King Street Pump Station Improvements (Volume I) & ASR Lime System Improvements (Volume II) - RFCSP
Solicitation Number: CO-00670
Job No.: 20-6002 and 22-8603

ADDENDUM 12
January 09, 2024

1 OSHG BLDG & BRINE TANK
SCALE: 3/8" = 1'-0"

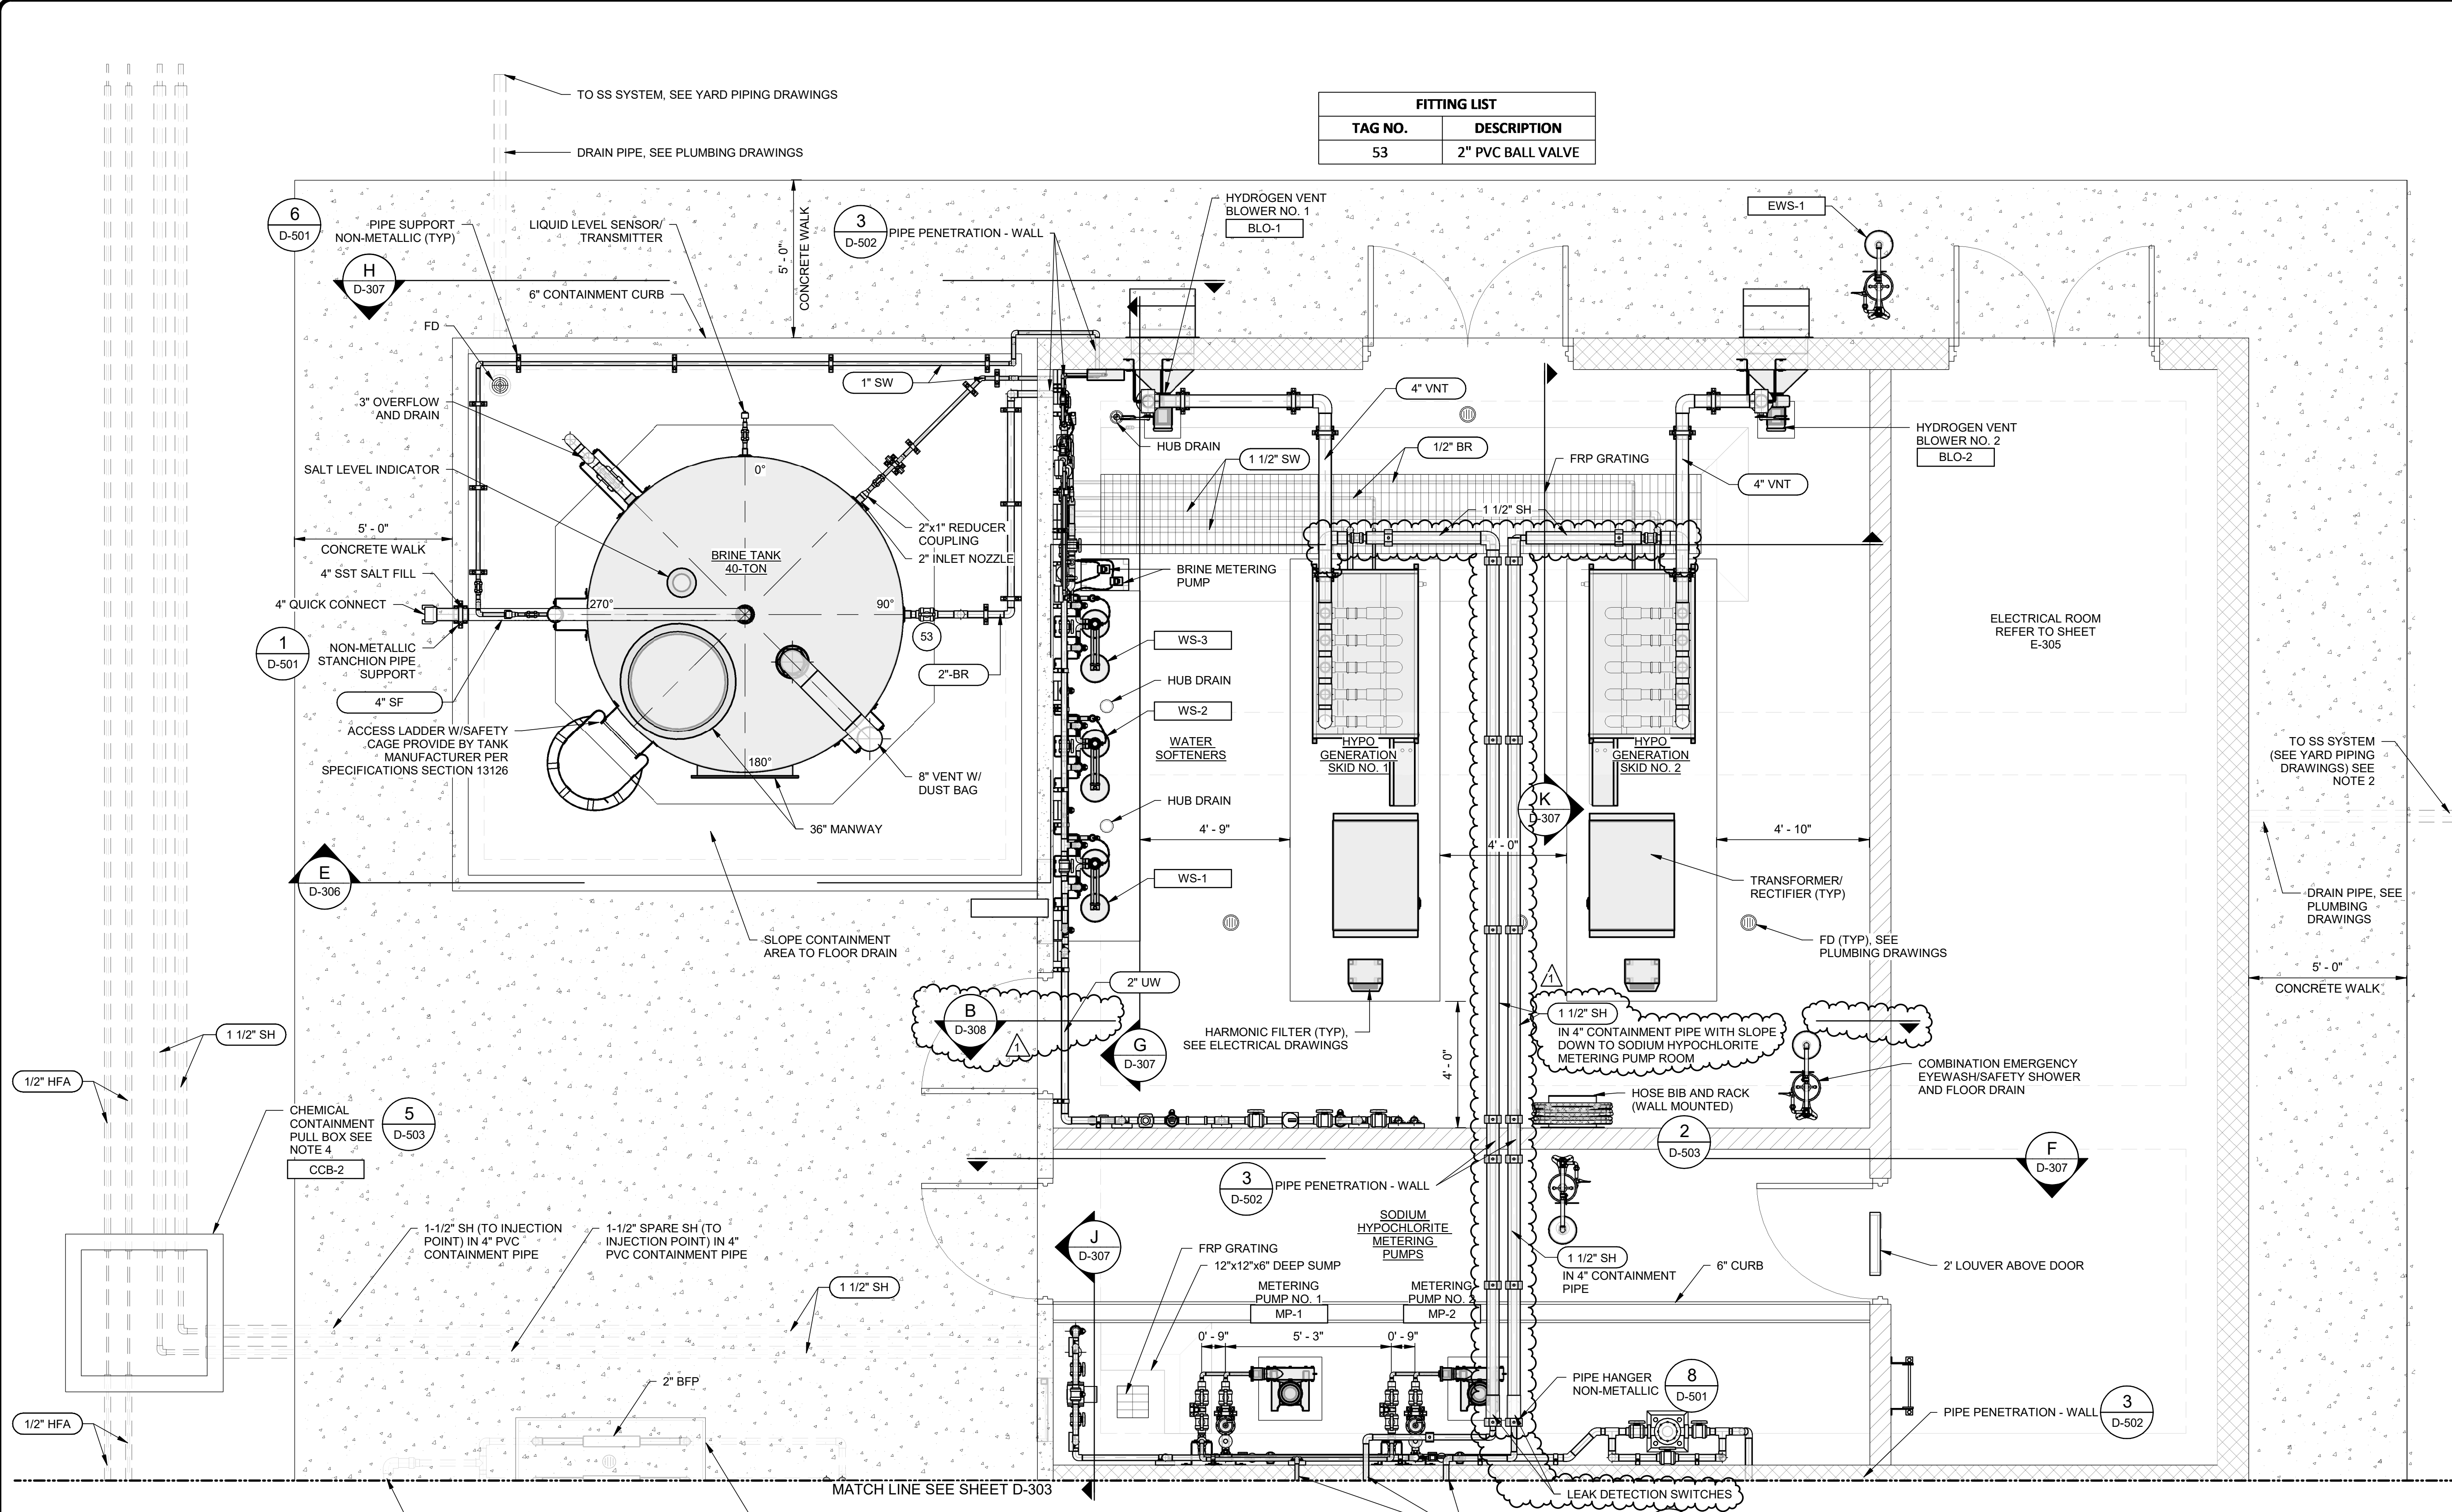
- 18. Volume I-King St PS Improvements: Can you provide a cut of the south wall inside the Hypo Generation Room? We need to see how the pipe is laid out.**

Response: Double containment and leak sensors for hypo system shown. Refer to "Changes to Plans" Item No 5, Item No 6, Item No 7, Item No 8, Item No 9, Item No 11, Item No 12, Item No 13 and Item No 14.

6. DRAWING D-302: OSHG BLDG AND BRINE TANK
 - DELETE in its entirety and REPLACE with the attached.
7. DRAWING D-303: FLUORIDE BLDG, TANK & HYPO BULK STORAGE TANKS

1 FLUORIDE BLDG, TANK & HYPO BULK STORAGE TANKS
SCALE: 3/8" = 1'-0"

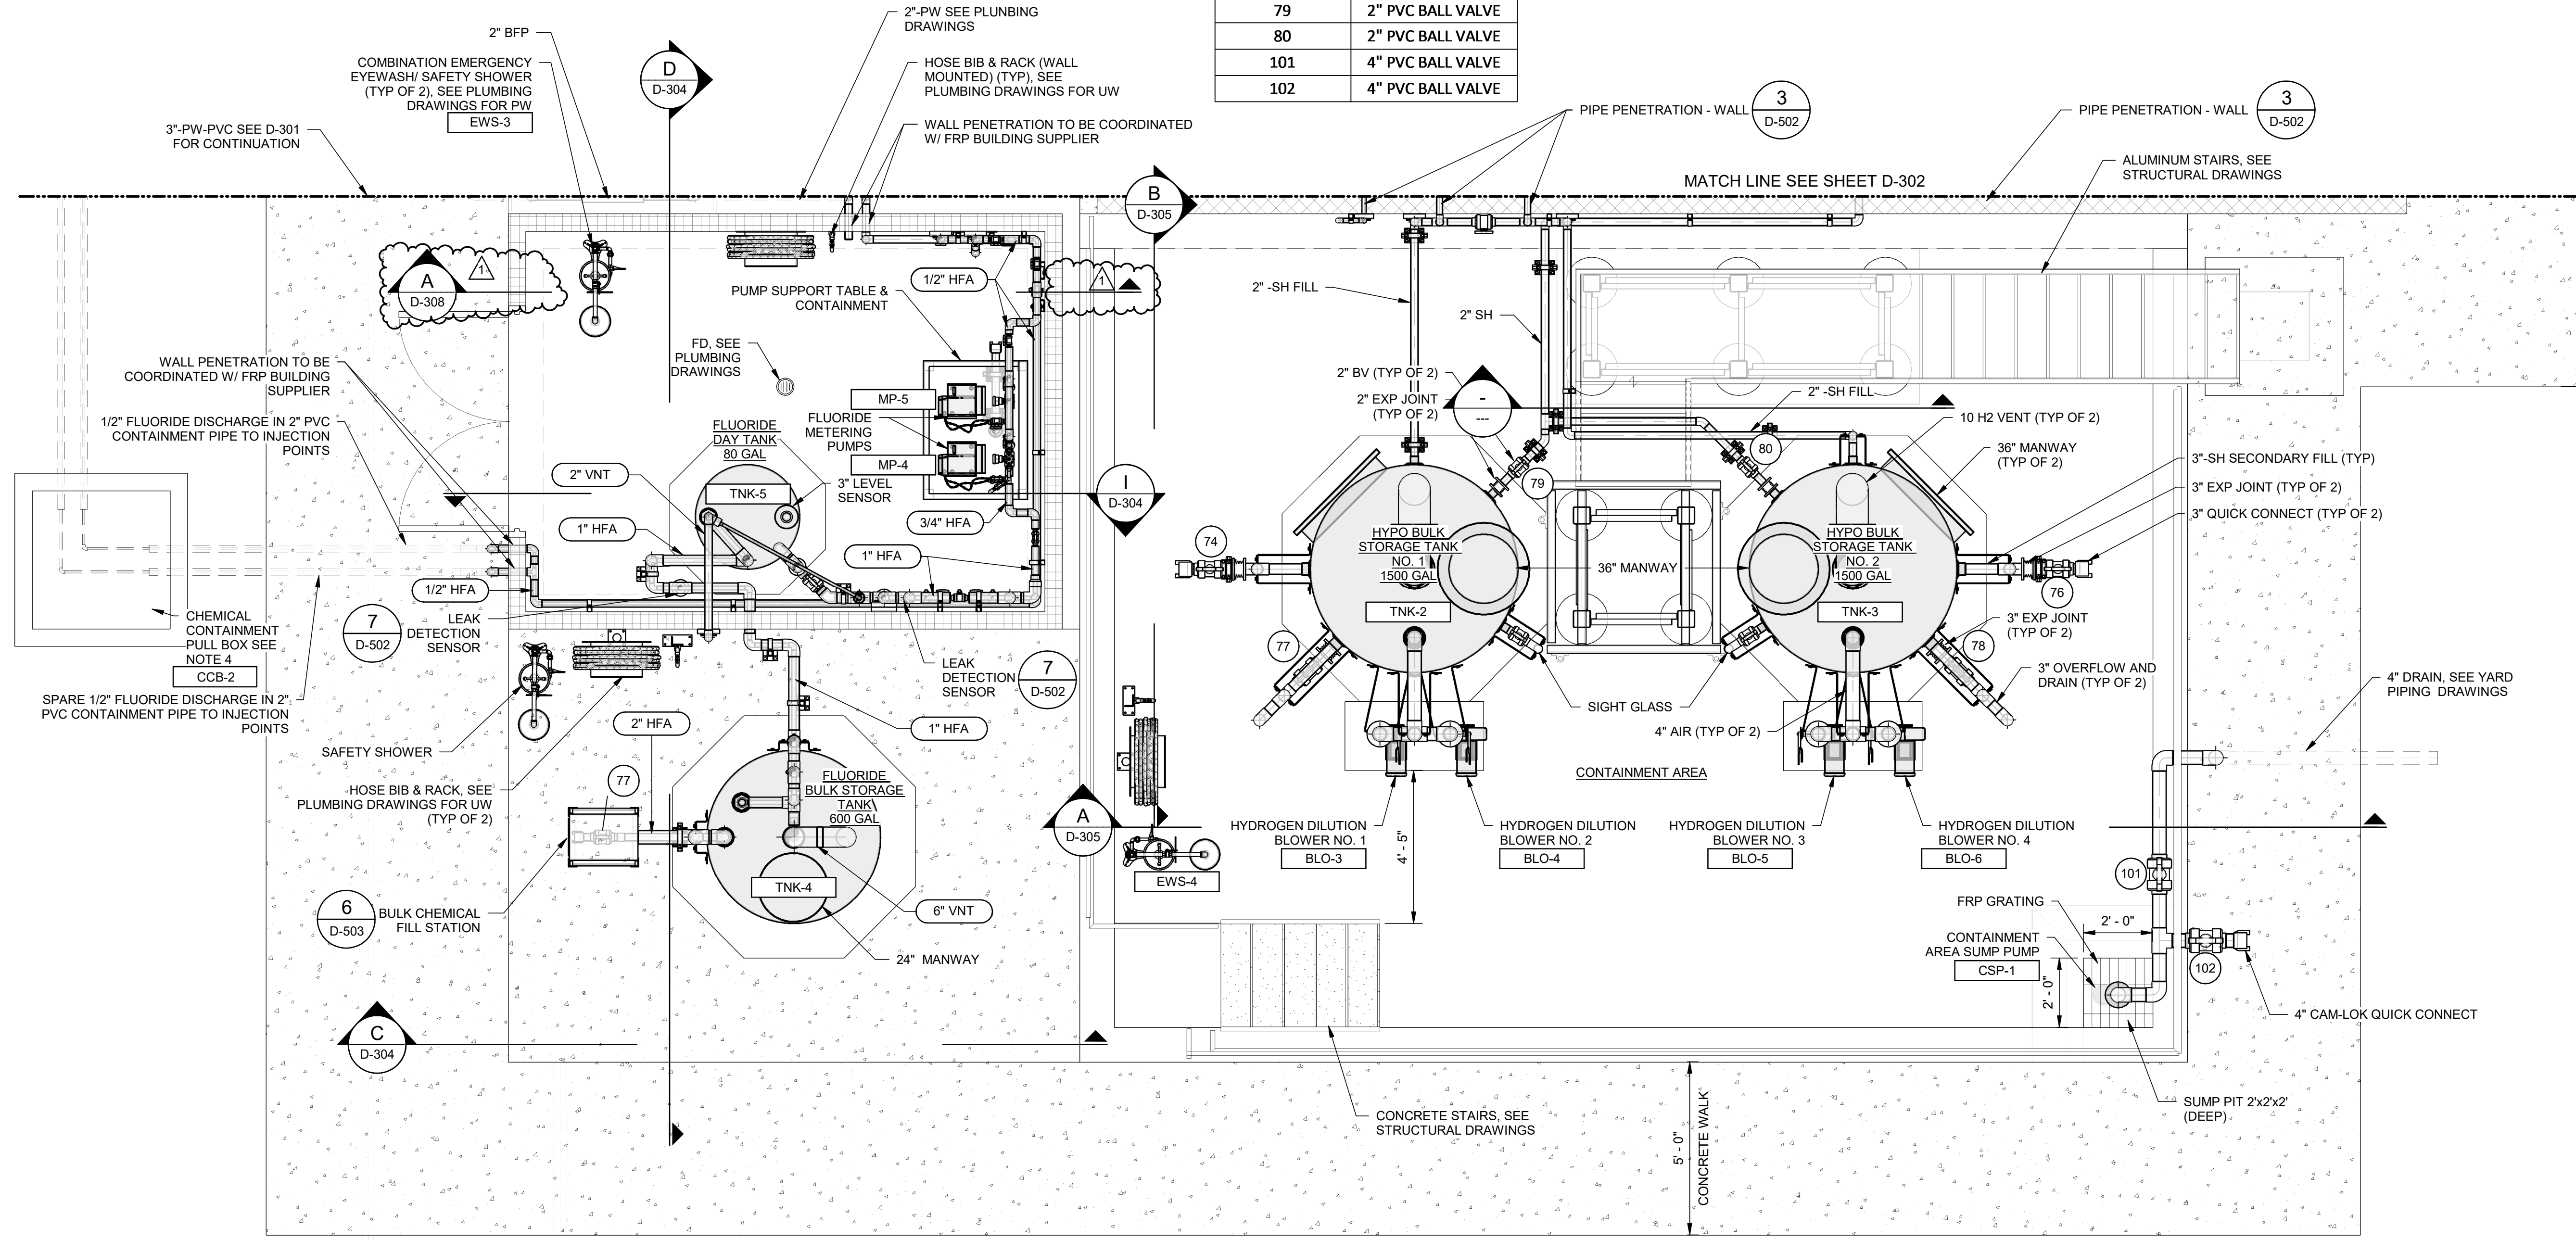
- 20. Volume I-King St PS Improvements: In regard to this project, the plans show an aluminum stair and platform in the demo section and in the structural. Do you know if this is something that needs to be quoted as new material?**

Response: The Sheet D-303 (Volume I) referenced in the attachment is not a demo sheet and is a process mechanical sheet. Aluminum stairs/platforms/rails are required to access the hypo bulk storage tanks. Aluminum railing is needed around the hypo bulk storage tank containment walls. These items are to be provided and installed by the contractor. The design of the stairs/platforms/railing is to be provided by the stair manufacturer's licensed engineer (refer to drawing S-504).

A NORTH WALL FLOURIDE BLDG
D-303 SCALE: 3/8" = 1'-0"

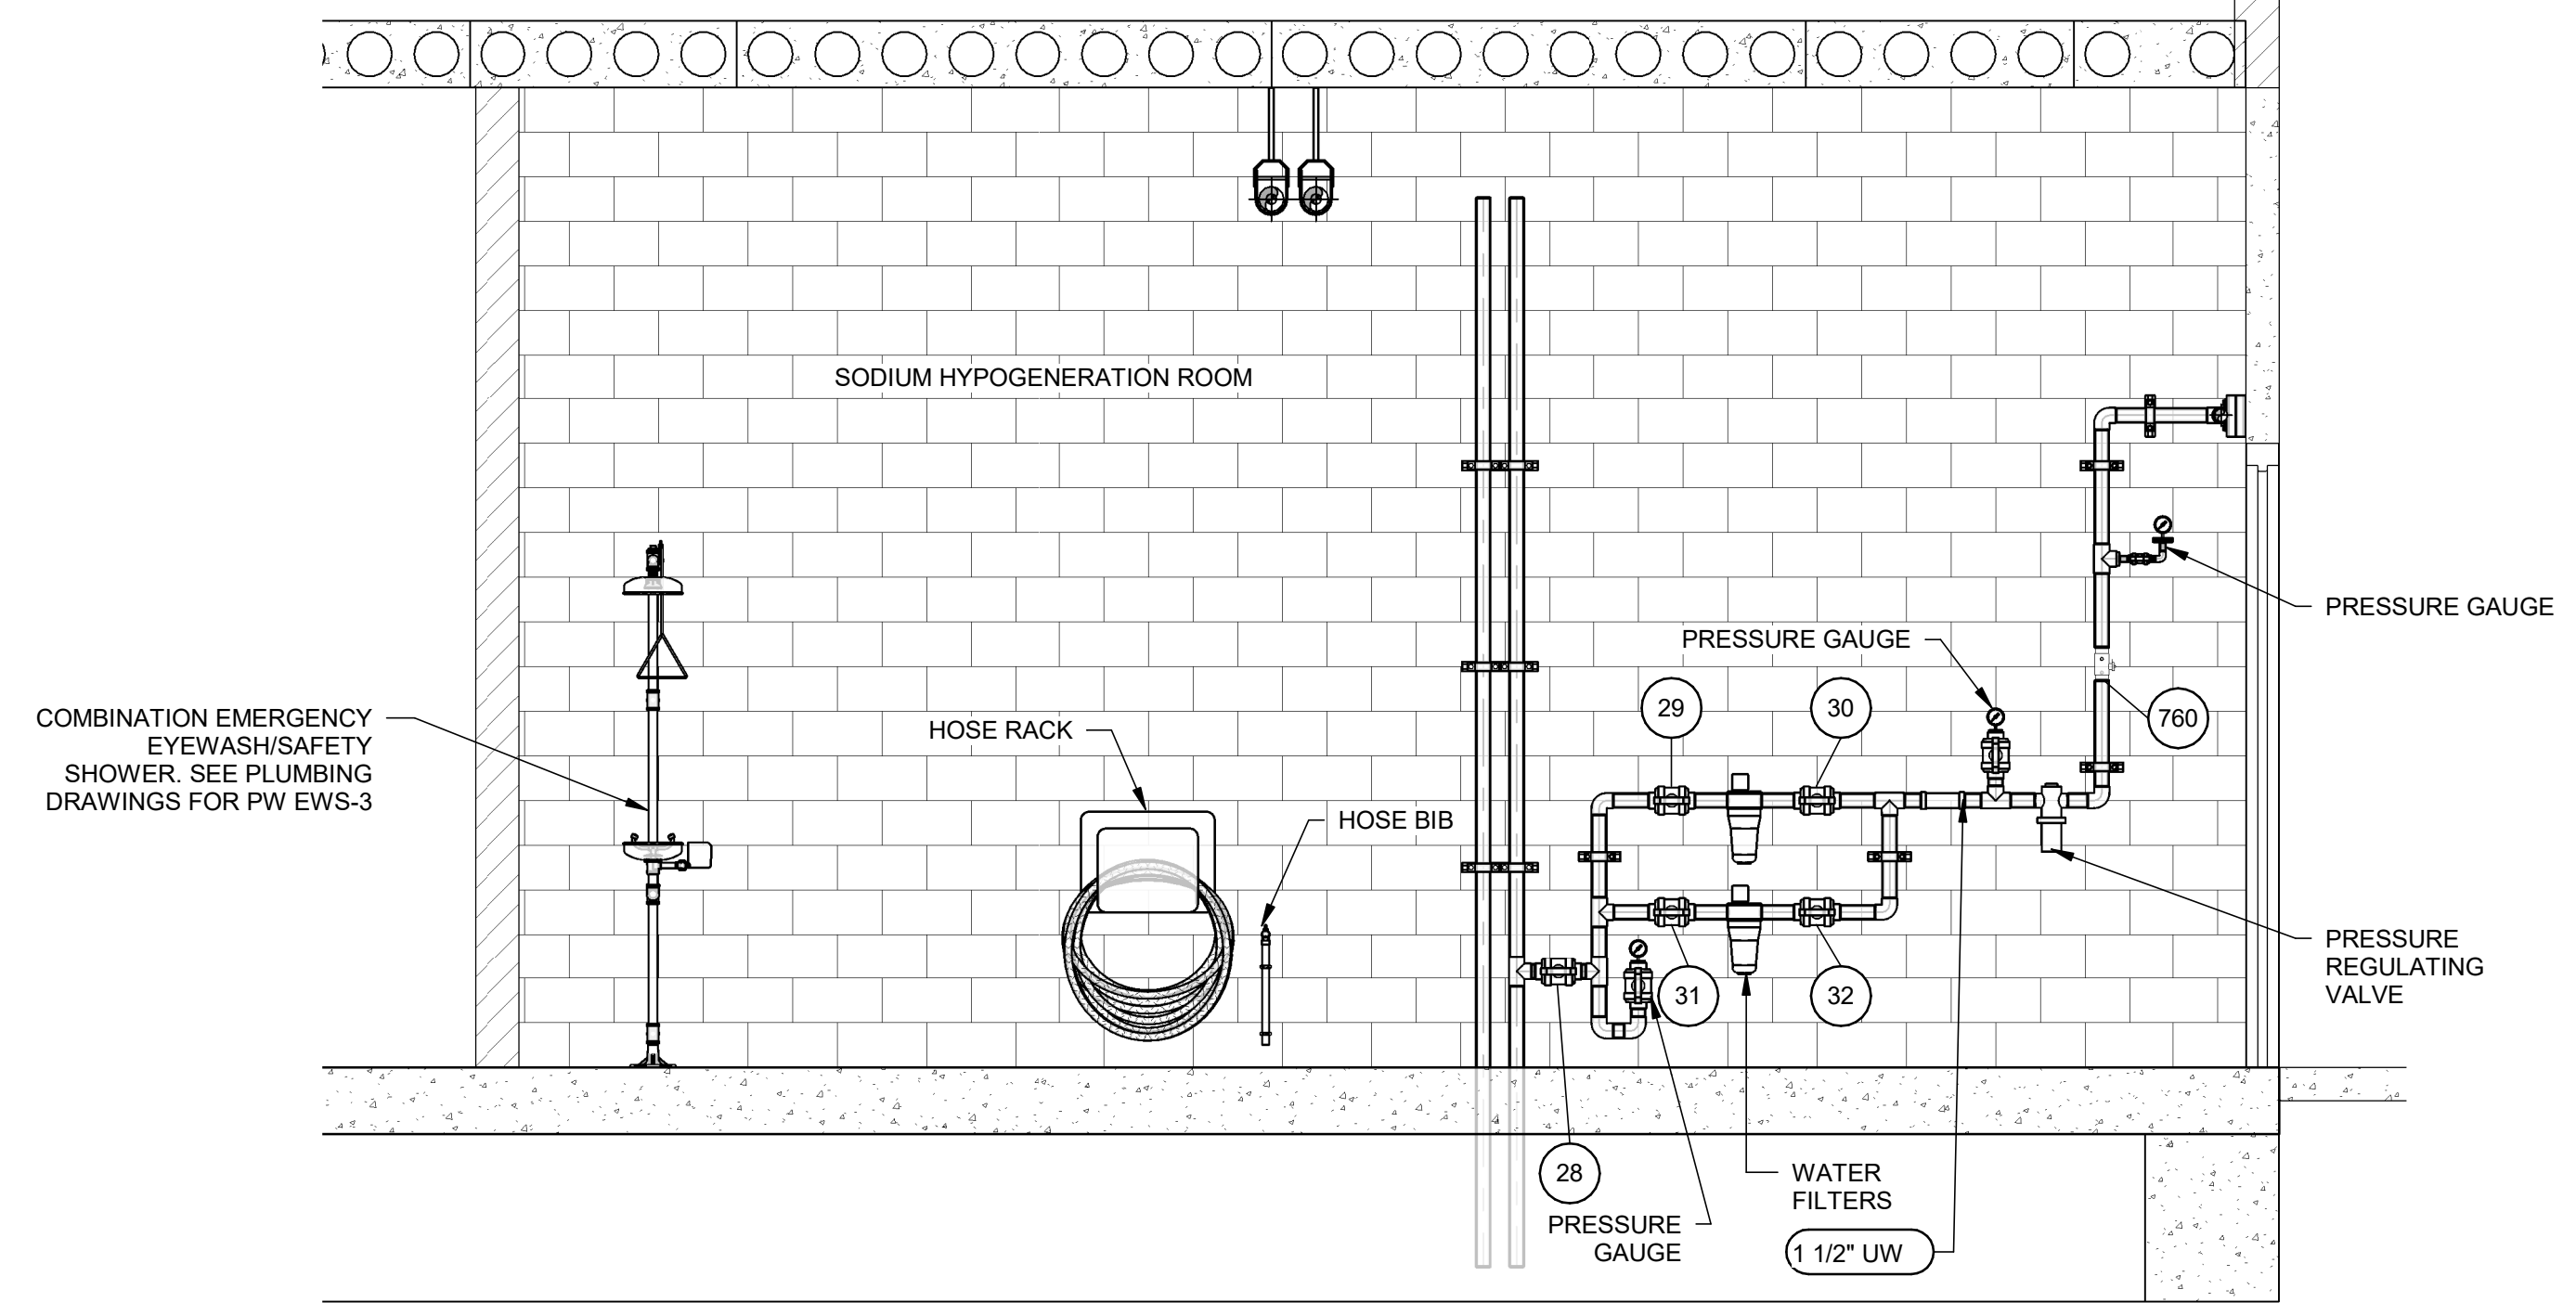
- 19. Volume I-King St PS Improvements: Can you provide a cut of the north wall inside the Fluoride Building? We need to see how the pipe is laid out.**

Response: Cut sections provided. Refer to "Changes to Plans" item no 2 and item no 10.

Response: Cut sections provided. Refer to "Changes to Plans" item no 2 and item no 10.

- DELETE in its entirety and REPLACE with the attached.
10. DRAWING D-308: ADDITIONAL BUILDING SECTIONS
 - ADD the sheet to the plan set.
11. DRAWING E-108: SITE PLAN MODIFICATION ENLARGED VIEW-II
